Panel Reference	2017SSH023
DA Number	DA2017/0138
LGA	Georges River Council
Proposed Development	This application seeks development consent for consolidation of the existing allotments, demolition of existing structures, site remediation and construction of a mixed use development. The proposal includes a supermarket and three (3) retail tenancies with shop top housing for 44 units and three (3) basement levels of car parking including loading facilities.
Street Address	160-178 Stoney Creek Road Beverly Hills
Applicant/Owner	Applicant: SJB Planning Owners: Cuzeno P/L
Date of DA lodgement	18 May 2017
Number of Submissions	Eight (8) submissions including sixty (60) signatures contained within a petition
Recommendation	Refusal
Regional Development Criteria (Schedule 7)	<p>Regional development is defined in Schedule 7 of State Environmental Planning Policy (State and Regional Development) 2011.</p> <p>Development with a capital investment value (CIV) over \$20Million</p> <p>The CIV of this application as outlined in the Registered Quantity Surveyors Detailed Cost Report is \$22,357,500.</p>

Report prepared by	Mark Raymundo Senior Development Assessment Officer
Report date	20 September

Figure 5 - Extract North and South elevation demonstrating the extent of the variation to height (Candelapas Associates, 2017).

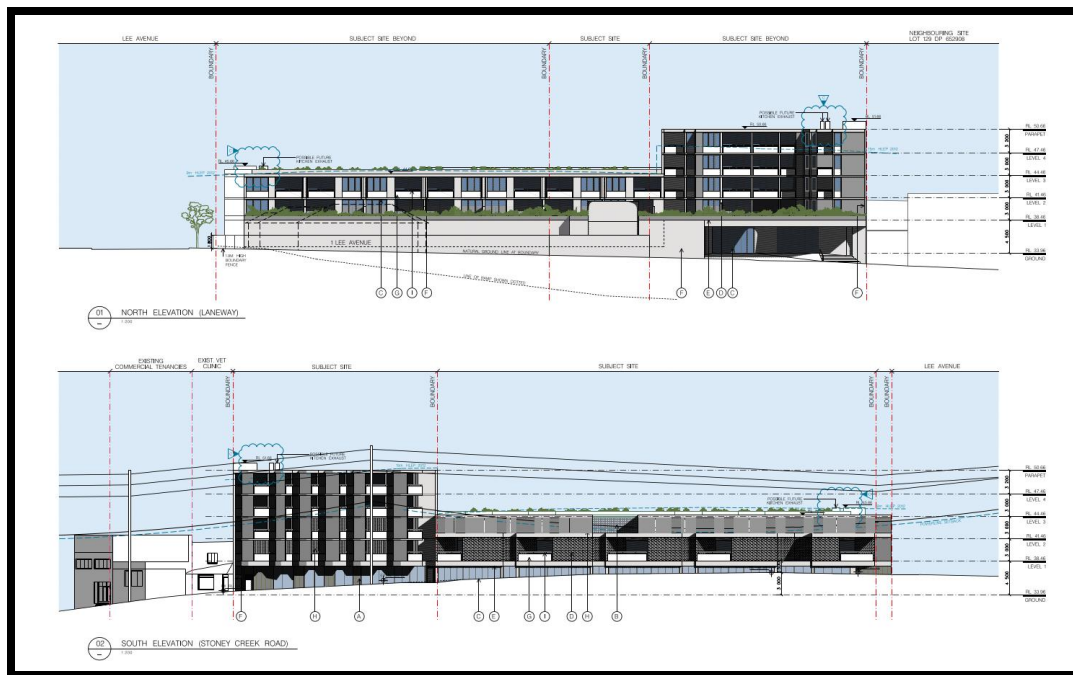
Officer Comment: A Clause 4.6 Exception to Development Standard for a breach in height is sought whereby the development exceeds the prescribed height of contained in the LEP, being a maximum of height of 17.92m (+19.4%). Clause 4.3 is not a clause excluded under Clause 5.4 Controls relating to miscellaneous uses under the HLEP 2012. The applicant has demonstrated the extent of the variation within the following architectural extracts below;

- The proposal results in excessive massing which was not envisaged by the controls when developed, the application will result in a building form and massing that was not envisaged for this location and therefore it is inconsistent with the desired future character of the Beverly Hills Town Centre.
- The majority of the residential fourth floor exceeds the height of building which is out of character and results in an undesirable present.
- The proposed exceedance in height is considered to be an overdevelopment of the site and is unnecessary.

Comment: The applicant's Clause 4.6 Exception for Development Standard relating to Clause 4.3 - Height of Building is not supported as the extent of the variation is not in the public interest as it is inconsistent with the objectives of the relevant standard and objectives of the zone as it will create a development form that was not envisaged in this location due to the excessive bulk and massing.

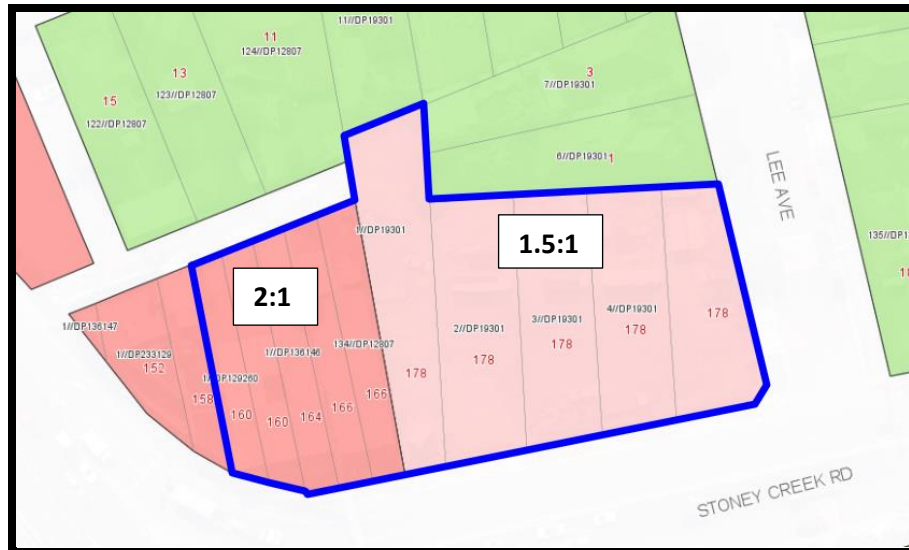
Officer Comment: A Clause 4.6 Exception to Development Standard has been prepared in accordance with the above seeking the following;

Development Standard	Proposed
T1 = 2:0	3:1 (+50%)
S = 1.5:1	1.62:1 (+8%)

The additional floor space is a result of the allocation of the car parking within the basement which is located across the site to service both the retail/supermarket and residential components. The application seeks 61% of the car parking being located in the western portion of the site and 39% is located within the eastern portion. The proposal has been amended to comply with the FSR above the ground level the western portion previously proposed at 2.1:1 which now complies at 1.96:1.

Officer Comment: The applicant's Clause 4.6 Exception for Development Standard relating to Clause 4.4 Floor Space Ratio is not supported as the extent of the variation is not in the public interest as is inconsistent with the objectives of the floor space ratio development standard and objectives of the zone. The proposed variation is not supported for the following reasons;
